## TECHNICAL EVALUATION REPORT

# HYDROLOGICAL CONSIDERATIONS (SEP, II-3.A, F

JERSEY CENTRAL POWER AND LIGHT COMPANY  
OYSTER CREEK NUCLEAR POWER PLANT

May 19, 1982  
Revised June 9, 1982

Figure 3. Site Layout

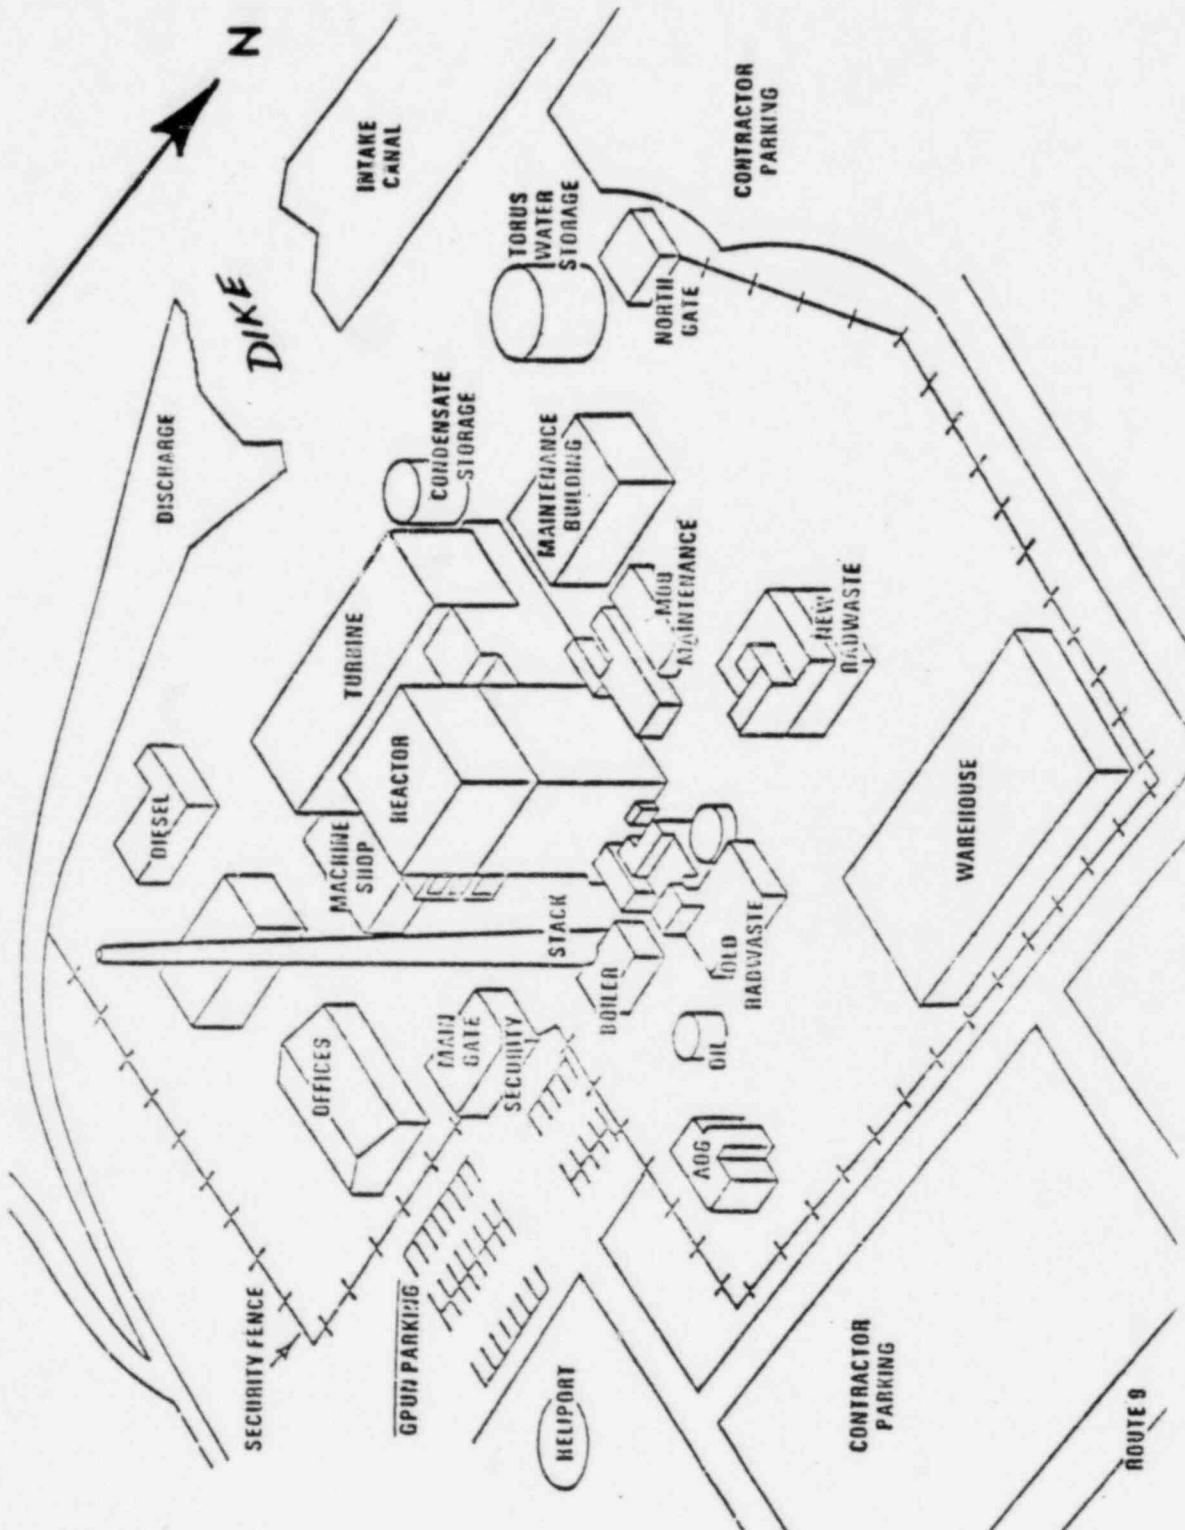
The plant structures (see Figure 3) were designed to withstand the hydrostatic and uplift pressures of groundwater to the following levels:

Local surface water users other than the Oyster Creek Nuclear Generating Station (if any) should be itemized. On all other points, the hydrologic environment is adequately described by the Licensee.
